Docket No. STN 52-001

Subject: Submittal Supporting Accelerated ABWR Schedule - **Containment Bypass**
(Issue #24)

Enclosed are SSAR markups addressing Suppression Bypass Issue #24. The markups include Section 6.2.1 (Containment Functional Design), Appendix 18A (Emergency Procedure Guidelines), Appendix 18B (Differences Between BWROG EPG Revision 4 and ABWR EPG), and Appendix 18D (Emergency Procedure Guidelines Input Data and Calculation Results). This information will be included in Amendment 30, scheduled for transmittal to the NRC on July 8, 1993.

Figure 6.2-~~xxx~~: Allowable Steam Bypass Leakage Capacity

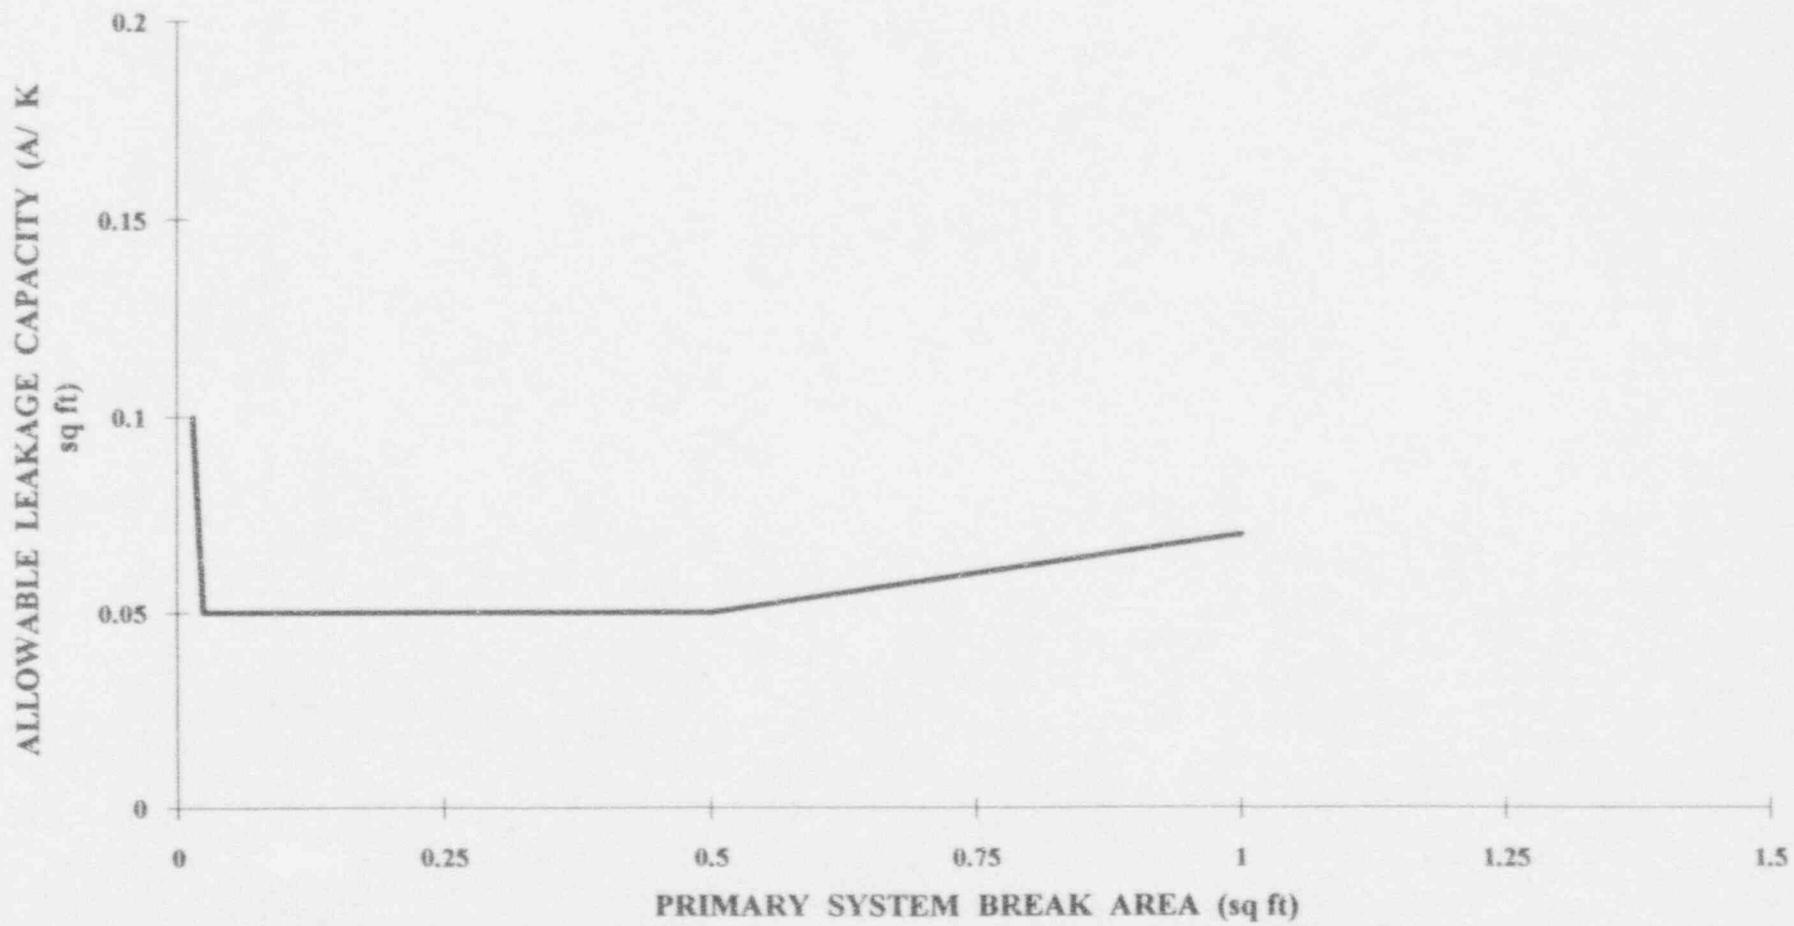
The containment system design provides two RHR spray loops, and each loop consists of both wetwell and drywell sprays. In operation of RHR in spray mode, the wetwell and drywell sprays activate simultaneously. Per loop, the design flow rate of drywell spray is about 800 m³/hour, and that of wetwell spray is about 114 m³/hour. In this analysis it is assumed that spray is to be initiated no sooner than 30 minutes after the wetwell gas space pressure is reached to 1.05 kg/cm² g. This assumed value of spray initiation pressure set point, which is higher than the EPGs pressure set point of 0.7 kg/cm² g, is expected to produce slightly conservative results. The suppression pool water passes through the RHR heat exchanger and is then injected into the drywell and wetwell spray headers located respectively in the upper region of drywell and wetwell gas space. The spray will rapidly condense the stratified steam, creating a homogeneous air-steam mixture in the containment. Structural heat sinks (drywell and wetwell boundary surfaces) were considered with variable convective heat transfer coefficients based on Uchida correlation. The reactor vessel shutdown rate was assumed to be 55.6° C/hr, and the maximum design service water temperature was used. This shutdown rate corresponds to the maximum rate which does not thermally cycle the reactor vessel. This analysis results in an allowable maximum steam bypass leakage capability of A/\sqrt{K} of 50 cm², meeting the criterion that calculated maximum containment pressure remain below the containment design pressure. Maximum steam bypass capability vs primary system break area is shown in Figure 6.2-~~xx~~ 42.

Containment sprays have a significant effect on the allowable steam bypass capability. Use of sprays increases the maximum allowable bypass leakage by an order of magnitude and represents an effective backup means of condensing bypass steam.

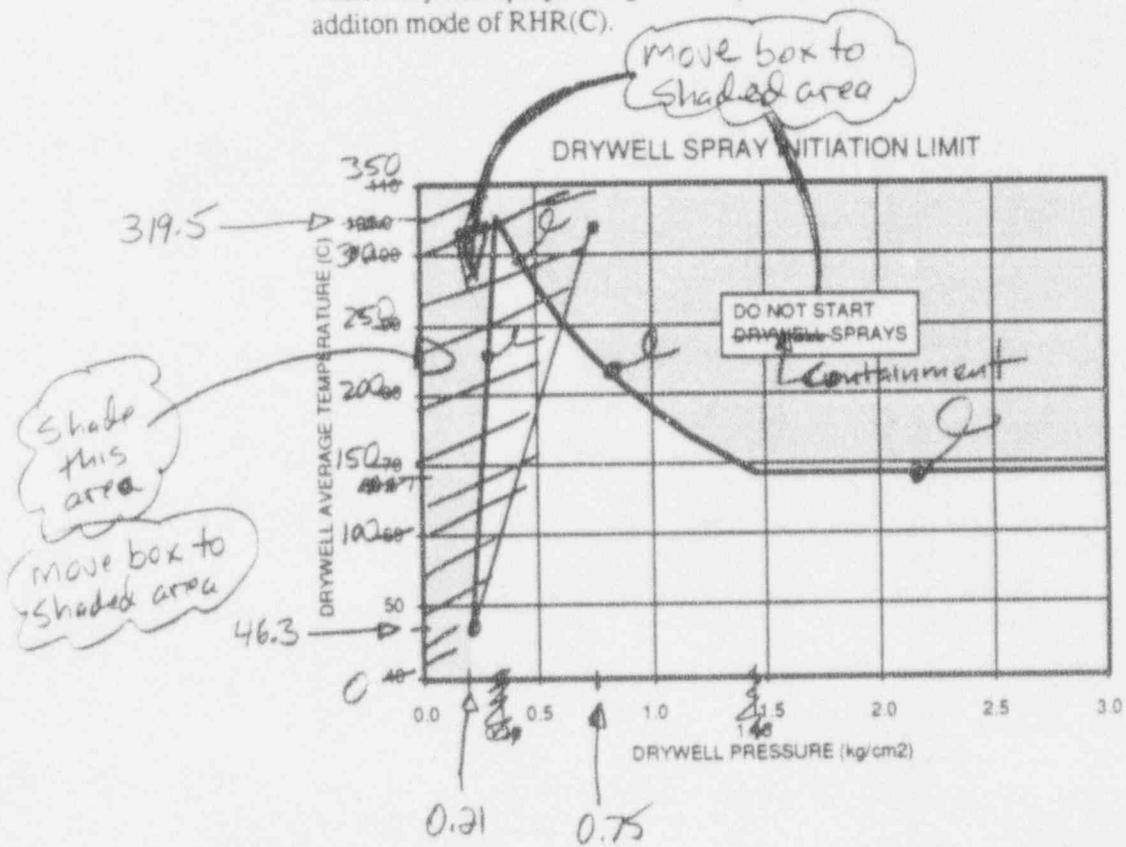
If while executing the following steps ^{Containment} ~~drywell~~ sprays have been initiated and drywell pressure drops below [0.12 kg/cm² g (high drywell pressure scram setpoint)], terminate ~~drywell~~ ^{Containment} sprays.

If RHR(B) and RHR(C) are not available for ~~drywell~~ ^{Containment} sprays, initiate ~~drywell~~ ^{Containment} sprays using the fire protection system and firewater addition mode of RHR(C).

DRYWELL SPRAY INITIATION LIMIT

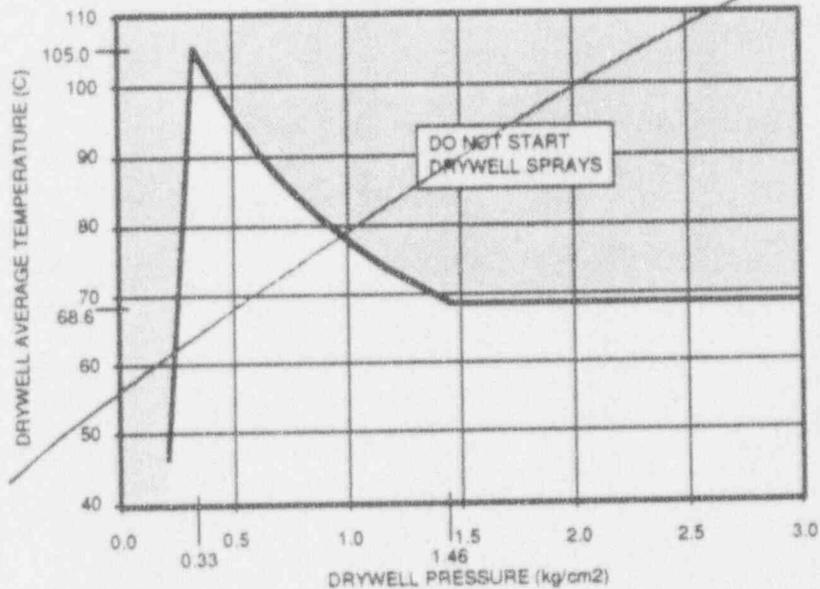
See revised
DSIL
on page
PC-5

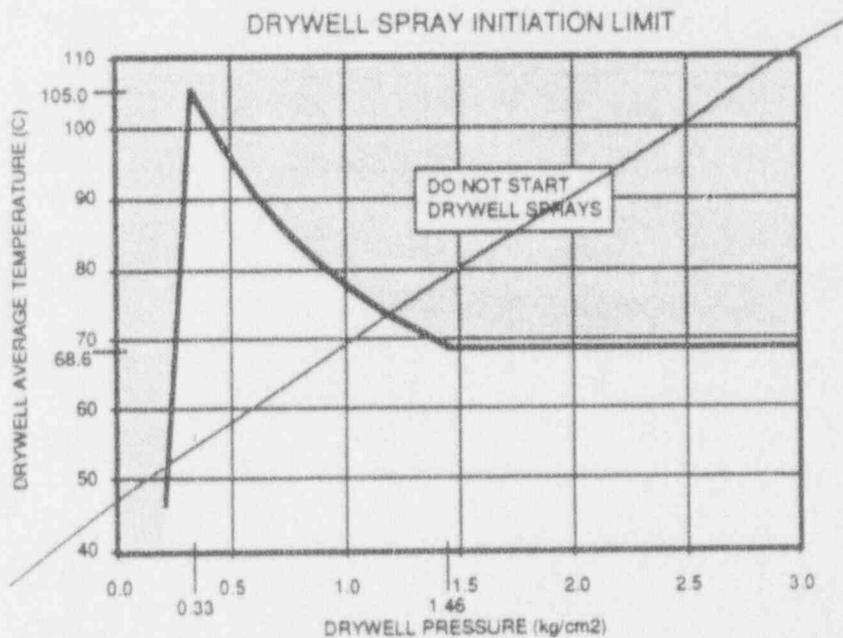
PC/H-4.4 If suppression pool water level is below [11.70 m (elevation of bottom of suppression pool-to-lower-drywell vent)] and drywell temperature, and pressure are within the Drywell Spray Initiation Limit, shut down drywell cooling fans and initiate ^{Containment} drywell sprays using only those RHR subsystems (RHR(B), RHR(C)) not required to assure adequate core cooling by continuous operation in the LPCF mode.

If RHR(B) and RHR(C) are not available for ^{Containment} drywell sprays, initiate ^{Containment} drywell sprays using the fire protection system and the firewater addition mode of RHR(C).

see revised DSIL on page PC-5

DRYWELL SPRAY INITIATION LIMIT

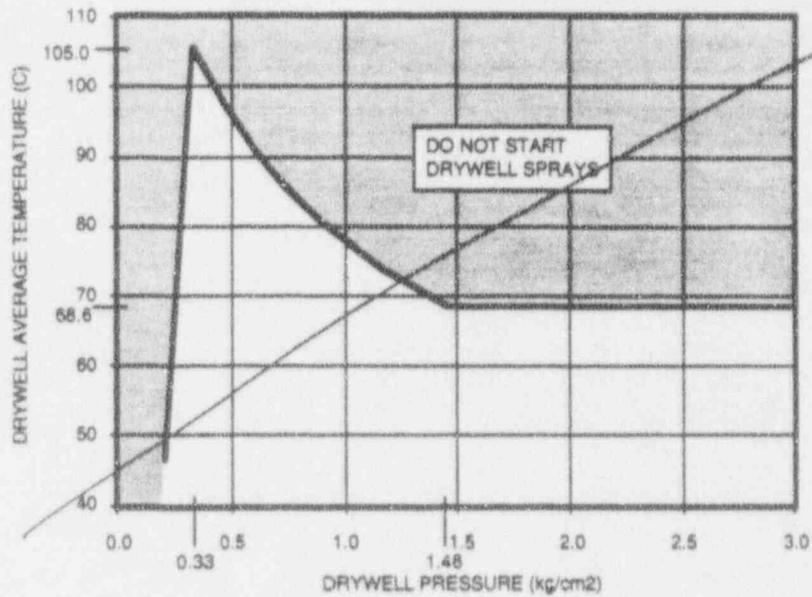
*see Revised
DSIL
on page
PC-5*
